Gate Burton Energy Park EN010131

Order Limits Change Supporting Environmental Information
Document Reference: EN010131/APP/8.25 (**Change Request**)
October 2023

FIGURE NUMBER
 Figure 1

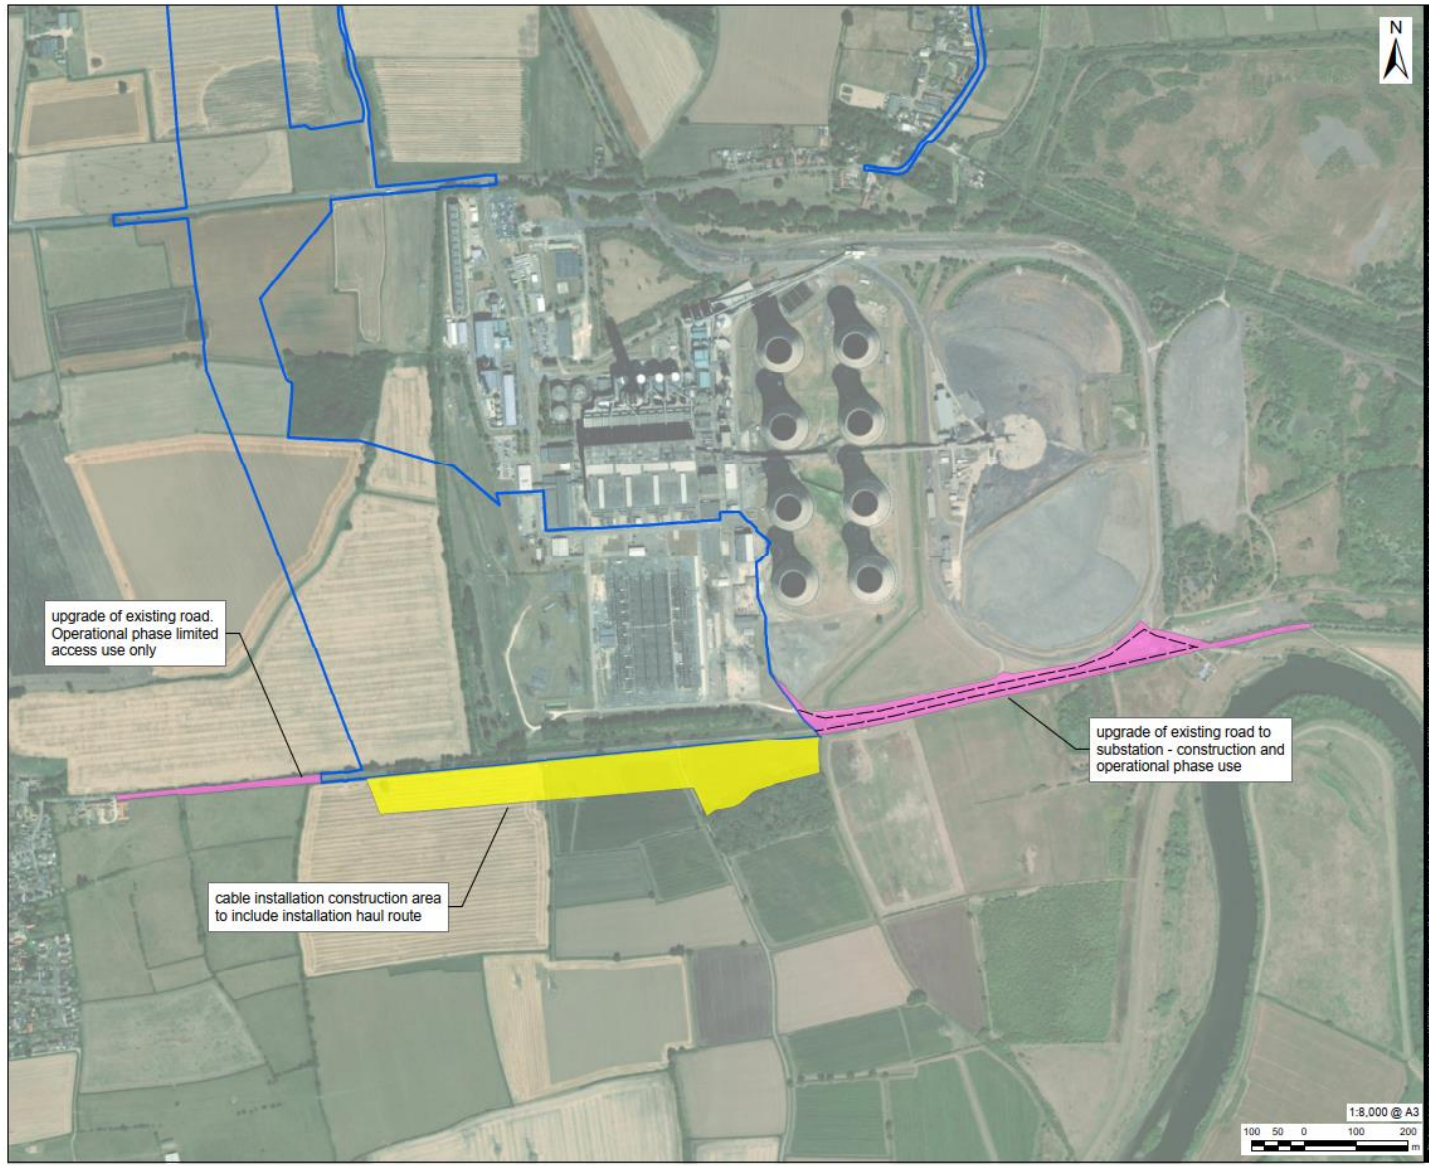
- Order limits change 1: an extension to the Order limits immediately to the south of Torksey Ferry Road for works to construct and operate the 400kV cable.
- Order limits change 2: an extension to the Order limits to the east and west along Torksey Ferry Road to accommodate access during construction and (for some parts of the road) during operation and extension to the Order limits immediately to the north of the eastern extension along Torksey Ferry Road (into EDF land) to accommodate access during construction;
- Order limits change 3: a reduction to the Order limits to the north of where Willingham Road meets Marton Road at the request of the land owner; and
- Order limits change 4: a reduction to the Order limits due to the removal of the Marton Road operational access from the Scheme following consultation with Lincolnshire County Council.

- 2.1.14 This change involves a reduction of 0.18 ha from the Order limits north of where Willingham Road meets Marton Road (**see Appendix A**), following a land owner request.

- 2.1.15 Following feedback from Lincolnshire County Council during Examination, an access review was undertaken to reconsider the access designs, locations and visibility splays to minimise the need for vegetation/hedgerow removal as detailed within **Access Updates and Cumulative Impact Assessment [REP2-045]**.
- 2.1.16 The reason for the removal of this access is to enable existing hedgerows to be retained as well as to ensure that the proposed early planting activities can take place in this location which is required for screening purposes. Access to this section of the Energy and Storage Park will be provided via the private means of access track adjacent to the junction of Marton Road and B1241 High Street (Access E) as shown on Figure 5.1 within the **Planning Design and Access Statement Part 2 [REP2-006]**.

FIGURE TITLE
 Order limits change 1: An extension to the Order limits to the south of Torkesey Ferry Road

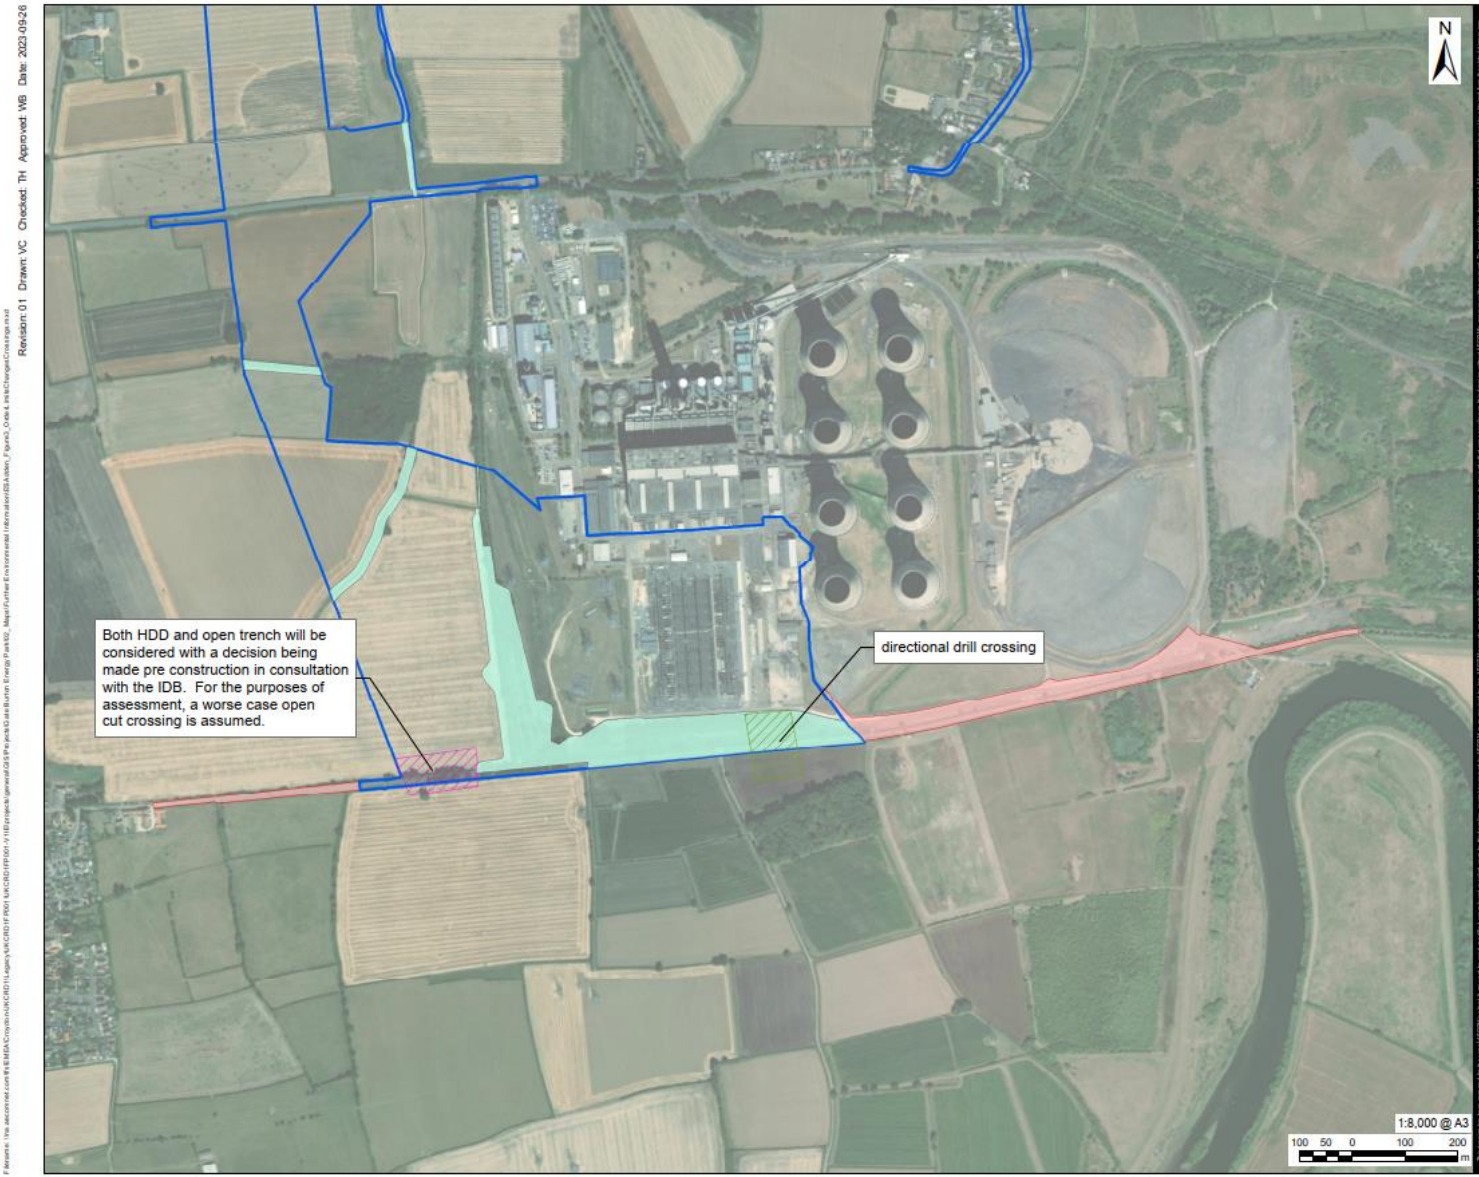
2.1.4 This change involves an extension to the Order limits to the south of Torksey Ferry Road which is required for works to construct and operate the 400kV cable.

- 2.1.8 There is a watercourse (Seymour Drain) to the south of Torksey Ferry Road. For the purposes of assessment, in the worst case scenario, it is assumed that the western crossing (see **Appendix A**) will be an open cut crossing. The crossing further to the east will be via a horizontal directional drilling method (HDD) (see **Appendix A**). In order to provide access for installation of the cable to the land to the south for construction vehicles, an existing access onto Shortleys Road will be upgraded which will require the widening of an existing structure crossing Shortleys Road.

- 2.1.9 The extension along Torksey Ferry Road and to the north of Torksey Ferry Road is included to enable construction access to the Substation using Torksey Ferry Road (Change 2). Torksey Ferry Road is designated as a Byway Open to All Traffic (BOAT13) that runs to the south of Cottam substation. The BOAT is currently used by pedestrians, horse-riders, light goods vehicles and 4x4s. The road upgrade will comprise compacted aggregate placed on top of the existing road. BOAT13 will remain open throughout the construction phase, except during a portion of the road upgrade works where the duration of any closure would be up to a maximum of 4 weeks.
